pd-trigger — Design Document

Brief: pd-trigger (S14 run c - novel brief chosen by the user)

Board review (P8 adversarial) - pd-trigger

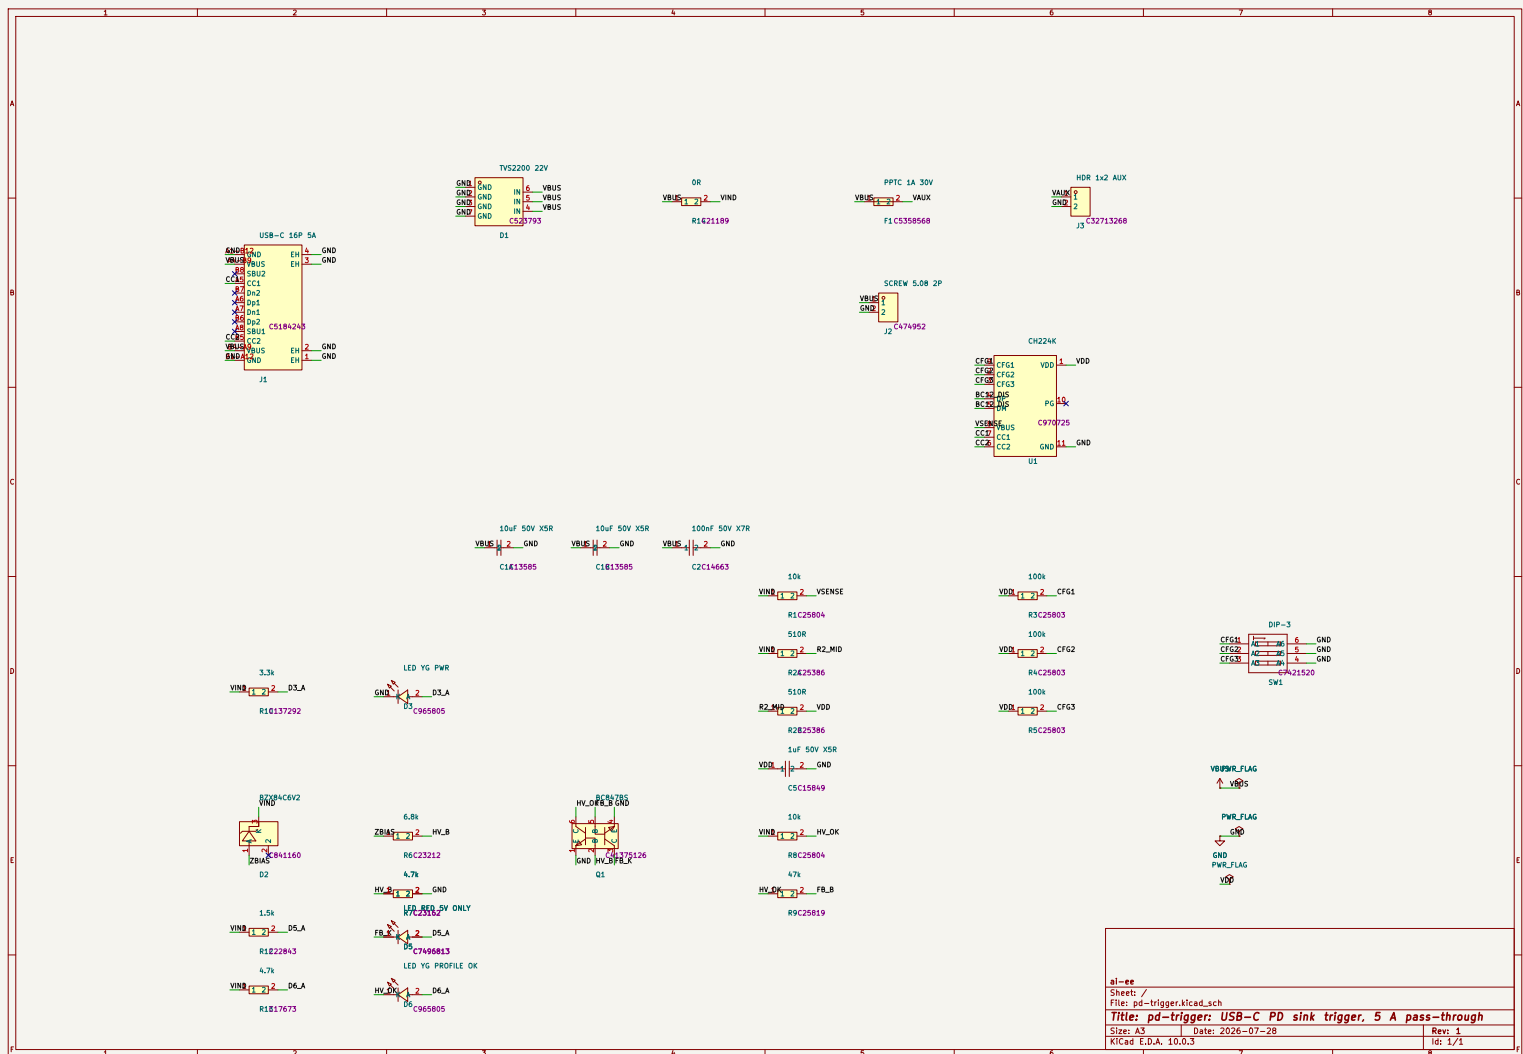
W1 dp-dm-short-at-chip: architecture’s PD-only short (`/BC12_DIS`) ACCEPTED by the reviewer as hardware-SAFER than the datasheet’s connector wiring (removes a 21V-onto-3.8V-abs-max fault path). Cost: no QC/BC legacy support - the board is “PD sources only”; goes on B.SilkS + order docs. W2 vdd-worst-corner: true worst case 0.979mA at 4.4V low-line all-straps- closed vs unpublished CH224K IDD - bounded by WCH’s own reference circuit; V1 bring-up step: measure VDD at the 5V profile; contingency = both 510R -> smaller (documented floor 600R total). Bring-up addenda: buzz out Q1 E/B/C once (clone PDF JS-gated; Nexperia- standard pinning verified as the compatibility claim).

reports/render_final/top.png

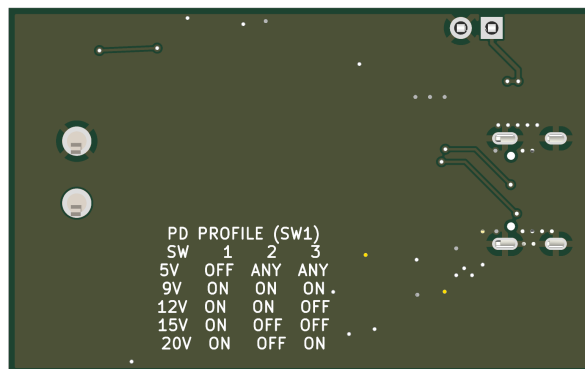
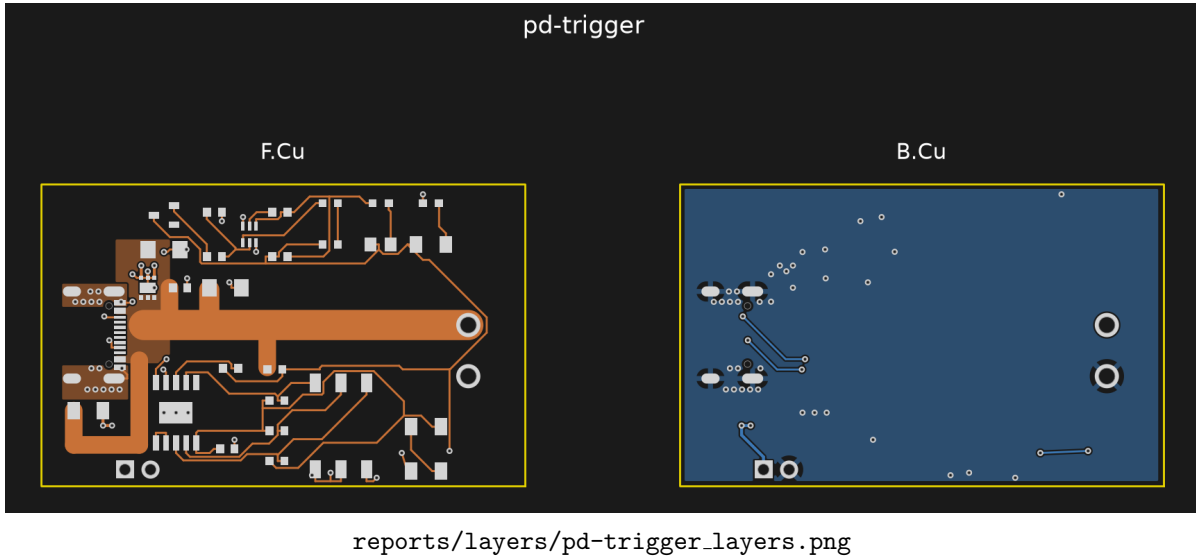
E1 - 5 A return chokes at J1's GND contact pads (error, checker-blind by design D7)

The 4 GND cable contacts land on two merged SMD pads (F.Cu only): A1-B12 at (17.63,39.31) and B1-A12 at (17.63,45.71), nominally 2.5 A each at the 5 A rating. Their ONLY copper into the B.Cu return pour:

- A1-B12 (top): a 0.2 mm wide, 2.7 mm long F.Cu chain (3 segments) into shell pad 1's THT barrel, plus one 0.6/0.3 via whose annulus grazes the pad corner by ~0.05 mm (etch-tolerance-level). 0.2 mm at 2 oz = 0.80 A capacity at 10 C rise (pipeline model); at 2.5 A the same model gives ~133 C rise (short-neck heatsinking will moderate this, but it is a >3x overcurrent on the model's own terms). ~13.6 squares = 3.3 mohm.
- B1-A12 (bottom): a 0.2 mm x 1.3 mm trace into ONE 0.6/0.3 via. The board's own via budget (constraints via_amps 0.5) says 2.5 A needs 5 vias; there is 1. Shell pad 4 sits 0.32 mm away but is NOT connected on F.Cu - its copper does not help.

Architecture D7/power_tree structural requirement ">= 10 vias at J1's GND pads" (the stated substitute for keeping GND out of power[] so check_current stays quiet): not delivered. DRC cannot see it (0.2 mm is netclass-legal), check_current cannot see it (GND undeclared), check_return_path no-ops (no high_speed key). Failure mode: sustained 5 A at any profile heats the two necks far past the 10 C design intent; long-term trace/joint fatigue, intermittent ground, and full return current cascading onto the surviving 0.2 mm chain. Fix is cheap at P9: an F.Cu GND spandrel bonding each contact pad to its shell pad (the VBUS pour top edge is at y 39.7 - the strip above it, and the strip x < 17.2 plus the region south of y 46, are free) plus 4-5 vias per side.

E2 - Safety/waiver silk markings absent (error, promised artifact) Board-wide gr.text count is ZERO; B.SilkS carries nothing at all (both B.SilkS references in the file are the stackup layer table). Missing, each one a written promise:

- AUX 1A MAX + V+/GND at J3 (P0 answer 4 "silk-marked", V10). F1 makes overload safe-by-hardware, but polarity of the 2-pin aux header is unmarked.
- PD SOURCES ONLY (ERC waiver W1's standing condition: "goes on B.SilkS + order docs"). The waiver's silk half is currently unfulfilled.
- J2 screw-terminal polarity. Trunk lands on J2 pad 1 = the LOWER screw (board-bottom side); nothing anywhere tells the bench user which screw is V+. Reverse-wiring a load on a 100 W output is the single easiest field mistake this board can cause.

E3 - User-interface silk absent (error, promised artifact)

- The five-row profile table on B.SilkS - D3 calls silk "the user interface" and specifies the table verbatim; the bottom is a clean pour with room. Without it the ON/OFF-to-voltage map exists only off-board; a user WILL set 9 V expecting 12 V by trial and error. (Fail-safe floor: any wrong guess >= the 5 V fallback, and OFF-fail = 5 V - the mistake is bounded but real.)

- LED legends PWR / 5V ONLY / PROFILE OK (D4/V10): the render shows refdes D3/D5/D6 only. The entire P0-answer-6 "visible fallback indication" scheme is mute without the words - a lit red LED labeled "D5" indicates nothing.

- Cable disclaimer "20V @ 5A needs a 5A e-marked cable and a 100W source" (V10 lists it as silk; power_tree s7 allows documentation - at minimum it must reach the order docs at P9/P10, which do not exist yet; fab/ is empty).

W1 - J1 mouth recessed ~0.4-0.5 mm behind the board edge (warning, flagged at P6) Courtyard/silk front edge $x = 10.18$ vs board edge $x = 9.8$. USB-C receptacles are normally flush-to-overhanging; a recessed mouth lets thick/molded plug overmolds butt the board edge and hold the plug fractionally short of latch - intermittent CC, no PD, "works with some cables". On a bare bench board with arbitrary cables this is a real annoyance risk. Fix: nudge J1 -x 0.5-1.0 mm at P9 (pour edge follows; nothing else in that corridor), or accept and note in order docs.

W2 - Outline 48 x 30 mm exceeds the architecture's hard ceiling (warning, drift) Edge.Cuts = (9.8,27.51)-(57.8,57.51) = 48 x 30 mm. D9: nominal 45 x 25, "hard ceiling 48 x 28 mm"; 30 mm violates D9's own ceiling by 2 mm even though it equals P0 answer 5's literal +20 % (40x25 -> 48x30, +44 % area vs the brief's target). No digest discloses the growth past D9. Consequence is cost/footprint only, but it must be disclosed to the user at the checkpoint rather than discovered.

```
# P8 digest (pd-trigger)
verify PASS 8/8 first try. Fable reviewer: 4 err + 2 warn. Copper errors
REAL: 5A RETURN choked at J1 GND pads (0.2mm necks/0.80A, 1 via) - rebuilt
w/ priority-1 F.Cu GND lobes (connect.pads solid) + 15 new 0.6/0.3 vias ->
5.68A/4.70A per pad, 16 vias (D7 >=10 met). Removed 2 stitch vias 0.121mm
from THT drills - LIVE-PROVEN KiCad DRC blind spot (via-drill vs same-net
pad-drill never checked, finding 34). Silk errors: 17 texts added; agent
CORRECTED the orchestrator's B-table spec (raw CFG bits would be inverted
vs ON=GND switch reality - printed switch positions). Warns: mouth recess
-> order docs; outline 48x30 deviation recorded; C1B channels waived w/
numbers. Re-gates: drc_routed 0/0, verify 8/8. H4 AUTO-approved.
```
